Campaign No. 96-0572

Recall Campaign Bulletin

MODEL 140, 129 (ENGINE 119, 120)

EMISSION CONTROL INFORMATION LABEL REPLACEMENT

Figure 1 096-0572

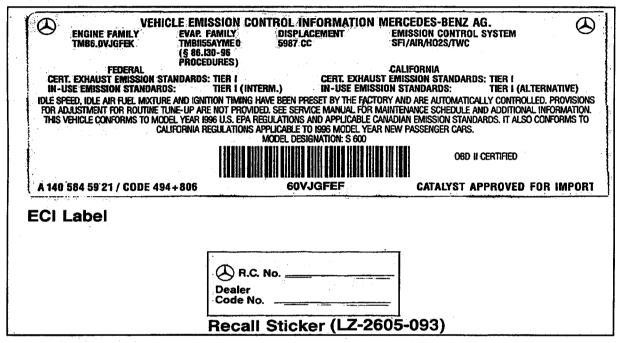
MBAG has recently informed us that the Emission Control Information (ECI) label (Figure 1) affixed to the radiator cross-member on approximately 4300 early production model year 1996 model 129, 140 vehicles equipped with V8 or V12 engines contains an error.

The error is in the bar code on the emission control information label and the engine family designation. The bar code does not agree with the engine family text description. The label with the wrong bar code was installed in production in the serial number range indicated below.

The incorrect ECI label (Figure 1) must be **replaced** with the correct version during the vehicle's next scheduled maintenance or repair (see Parts Information on this page) or at an appointment made by the customer to have the correction made.

To replace the ECI label, carefully remove the incorrect label. Clean the surface and affix the correct ECI label at the same location.

After completion of the campaign, write the recall number 96-0572 and dealer code on the appropriate location on the recall sticker (LZ-2605-093) (Figure 1) and affix the recall sticker to the driver's door A-pillar.
